Midway City Council
7 September 2021
Regular Meeting

Resolution 2021-27 /
Watts Remund Farms
Master Plan Agreement
Second Amendment

CITY COUNCIL MEETING STAFF REPORT

DATE OF MEETING: September 7, 2021
NAME OF PROJECT: Watts Remund Farms Phases 4 & 5 PUD
NAME OF APPLICANT: Russ Watts – Watts Enterprises
AGENDA ITEM: Master Plan Amendment
LOCATION OF ITEM: 200 East 600 North
ZONING DESIGNATION: R-1-15

Exhibit 10

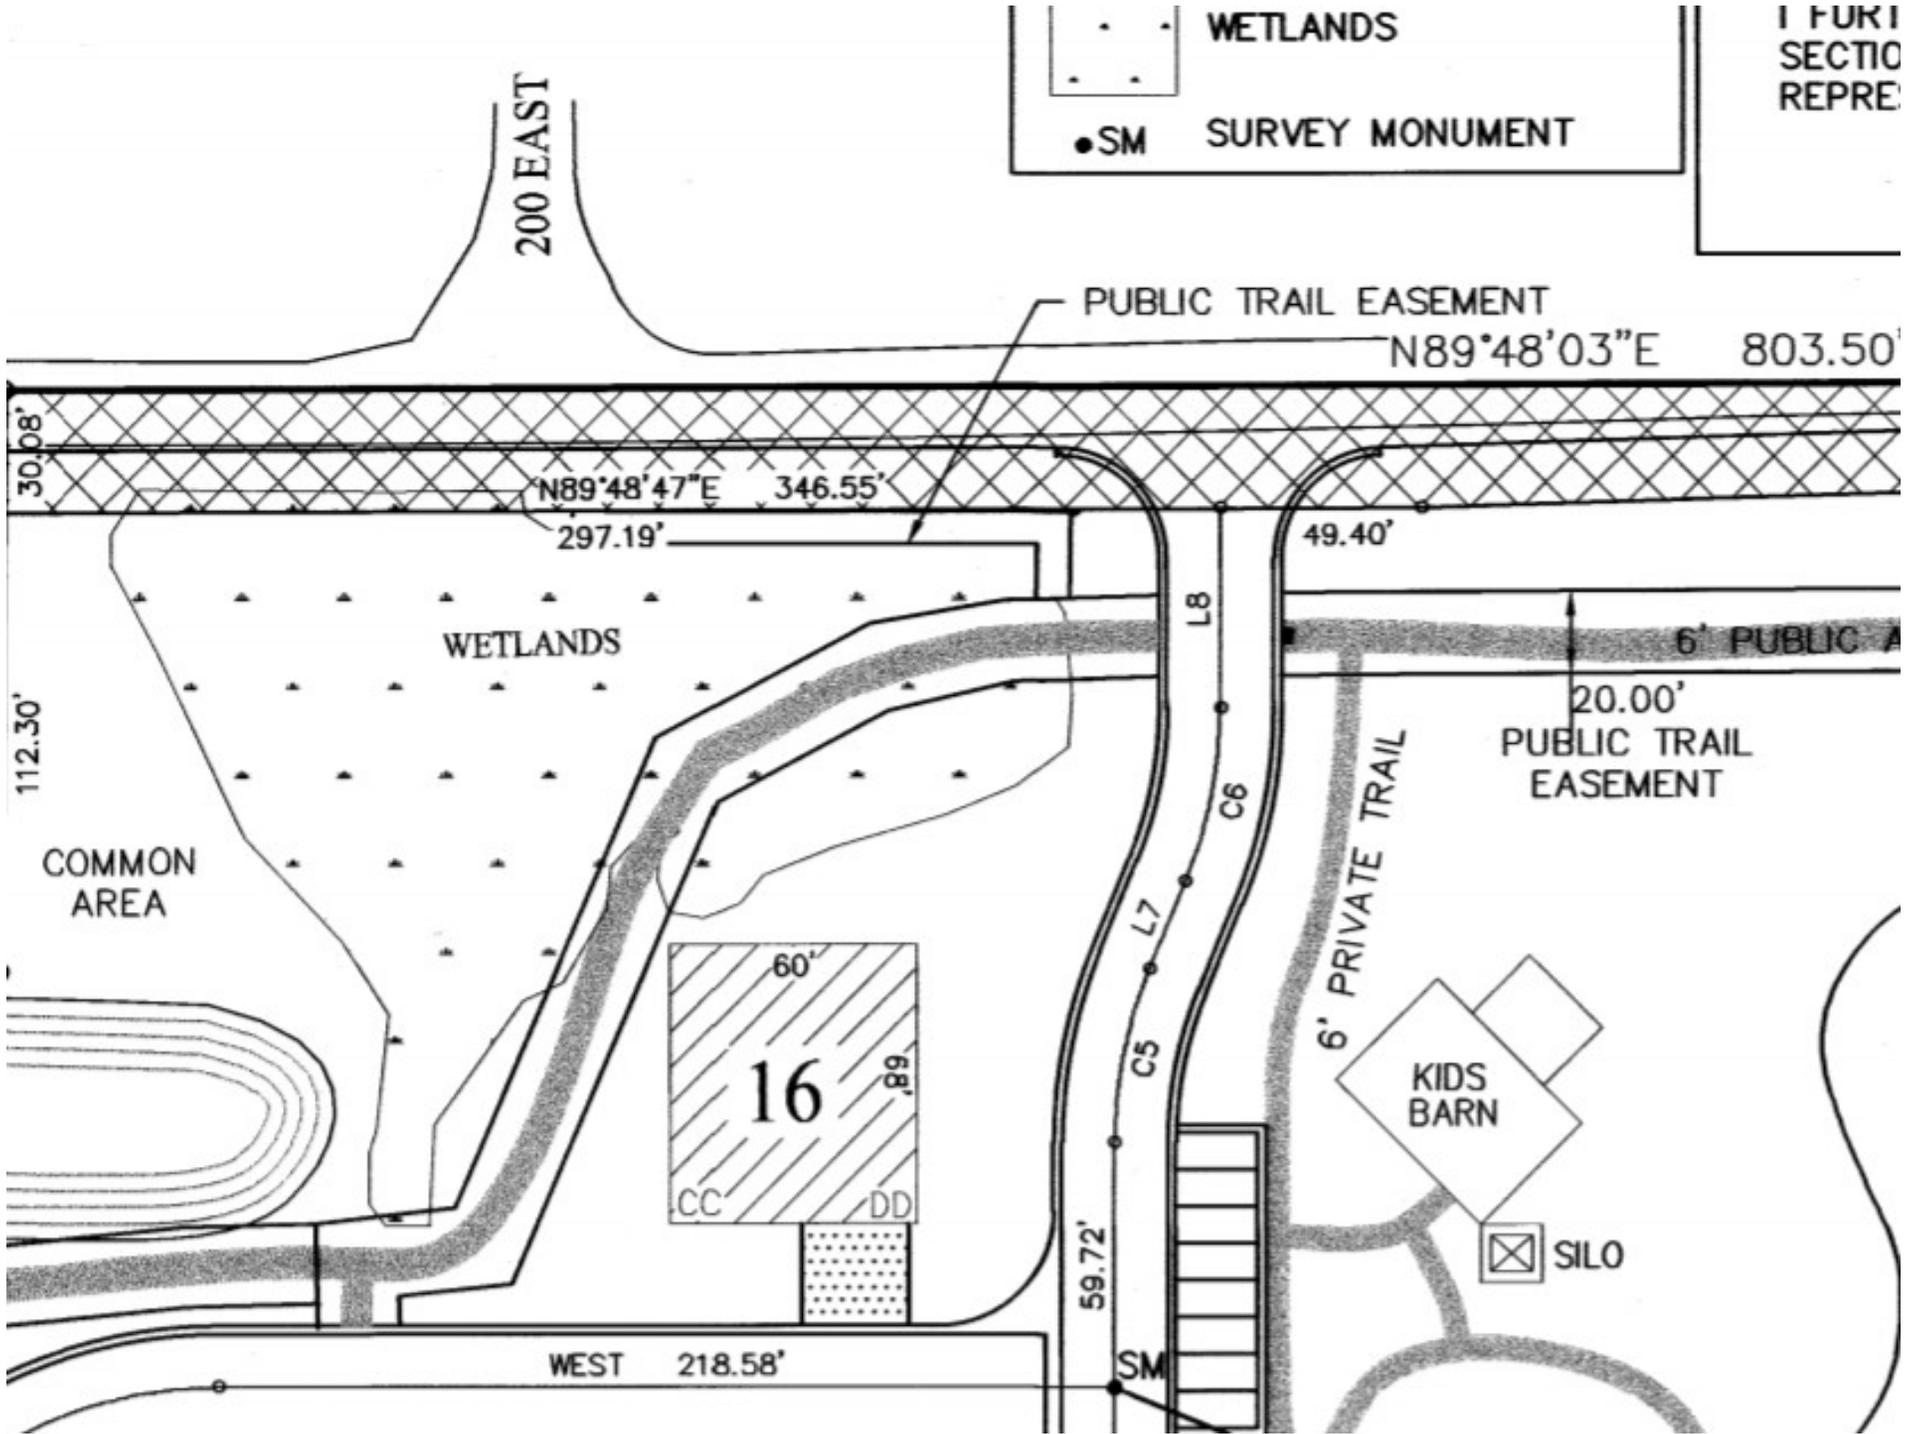
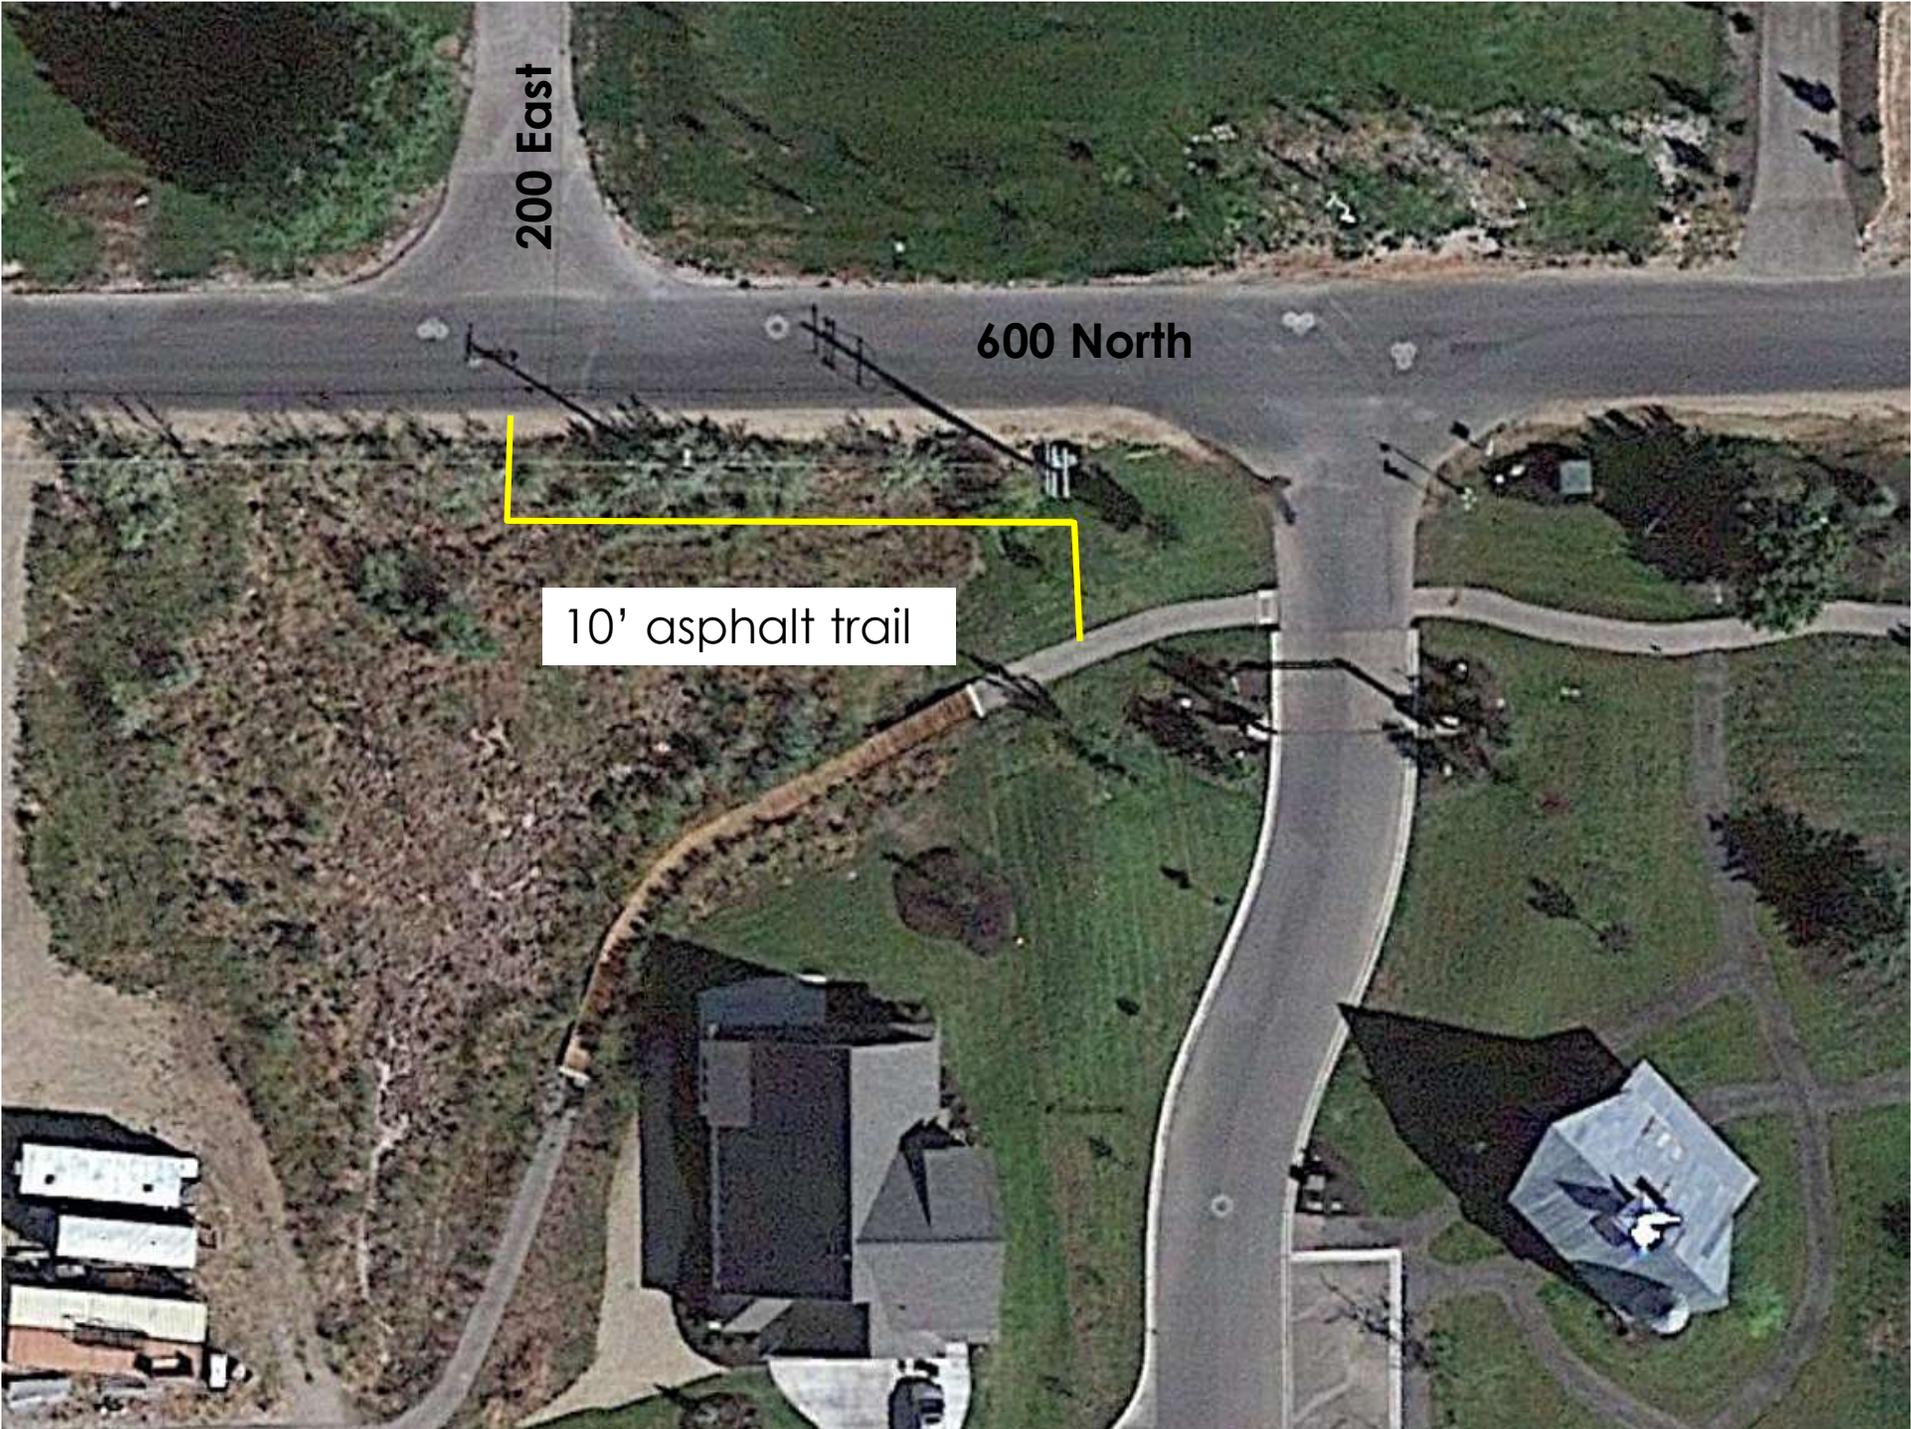
- The second condition would require the applicant to contribute the costs associated with paving an 8' onsite trail to the general trail fund so that that section of trail can be built with a future trail project. This small section will allow people to safely connect from the existing public trail in Remund Farms to the future trail that will run north along 200 East.. The trail is onsite, and the easement was dedicated with the phase 1 plat, but the trail has not been constructed and the funds to do so were not previously required.

10' asphalt trail

2. The applicant will be required to contribute the funds associated with installing the 8’ asphalt trail from Farm Hill Lane to 200 East to the general trails fund. The funds will be used when the trail is completed in the future as part of a larger improvement project.
